APPEAL SUMMARY

Appeal ID: 16550	Project Address: 2634 NE Broadway
Hearing Date: 2/28/18	Appellant Name: Alan Armstrong
Case No.: B-006	Appellant Phone: 5034426786
Appeal Type: Building	Plans Examiner/Inspector: Jerry Engelhardt
Project Type: commercial	Stories: 3 Occupancy: R-2 Construction Type: V-B
Building/Business Name: 2634 NE Broadway	Fire Sprinklers: Yes - throughout
Appeal Involves: occ Change from E to R-2	LUR or Permit Application No.: 17-274787-CO
Plan Submitted Option: pdf [File 1]	Proposed use: 5 unit apt building

APPEAL INFORMATION SHEET

SEPARATION WALL ASSEMBLY

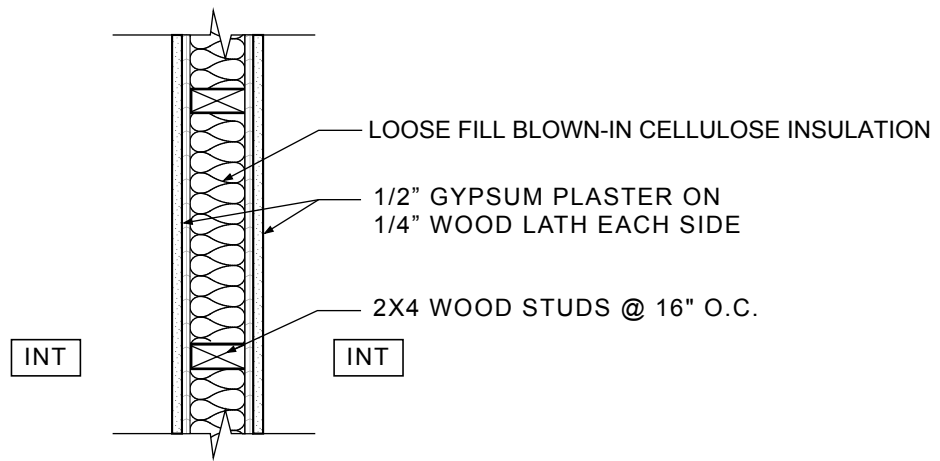
Propose that existing dwelling unit separation walls serve as adequate assembly. Existing walls are 2x4 studs @ 16" o.c. with wood lath and plaster each side and blown-in loose fill cellulose insulation filling each cavity.

Reason for alternative The existing wall assembly is comparable to assembly GA No. WP 3341 and GA No. WP 3260 shown on page 5 of the attached drawings.

GA No. WP 3341 consists of ¼" gypsum wallboard base layer and ½" gypsum wallboard face layer. It tests to 45-49 STC with no insulation.

GA No. WP 3260 consists of ¼" gypsum wallboard base layer and 5/8" type x gypsum wallboard face layer and laminating compound. It tests to 50-54 STC with 1 ½" batt insulation.

Therefore, it can be extrapolated that, in the worst case, the STC rating of the existing assembly would be no lower than 45 STC which would meet the code requirement for a tested assembly and that the probable STC is closer to the code required 50 STC.

1. Alternate Sound Transmission Class (STC) rating of wall assembly: Denied. Proposal does not provide equivalent Life Safety protection.

SEPARATION FLOOR ASSEMBLY

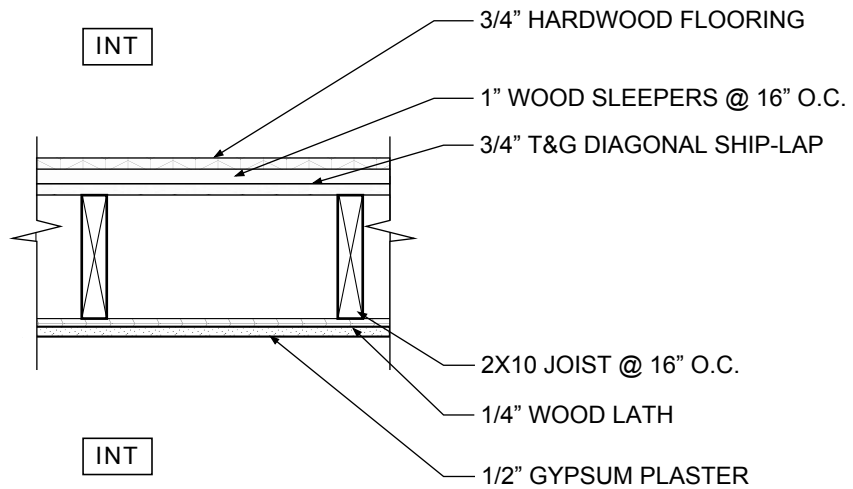
Code Section	OSSC 1207.2 and 1207.3
Requires	Floors separating dwelling units shall have a STC rating of 50 (field tested 45) and IIC rating of 50 (field tested 45).
Proposed Design	<p>The building was built as an apartment building in 1925. Occupancy was changed to E in 1986. We propose to return the occupancy to the original R-2.</p> <p>Propose that existing dwelling unit floor separation serves as adequate assembly. Existing floor assembly is ¾" hardwood floor on 1" wood sleepers on ¾" T&G diagonal ship-lap sheathing on 2x10 joists @ 16" o.c. with ¼" lath and ½" gypsum plaster ceiling finish.</p>
Reason for alternative	<p>Existing wall assembly is comparable to GA No. FC 5250 which consists of a double wood floor on 2x10 wood joists with RC channels and ½" gyp board ceiling and lists a STC of 45-49 and IIC of 39.</p> <p>Additional wood sleepers in the existing floor assembly push the extrapolated STC value to the upper end of the range which is close to the code required 50 STC. The additional wood sleepers also help boost the IIC rating as the wood to wood contact is reduced by the sleepers.</p>

3. Alternate Sound Transmission Class and Impact Insulation Class (STC / IIC) rating of floor / ceiling assembly: Denied. Proposal does not provide equivalent Life Safety protection.
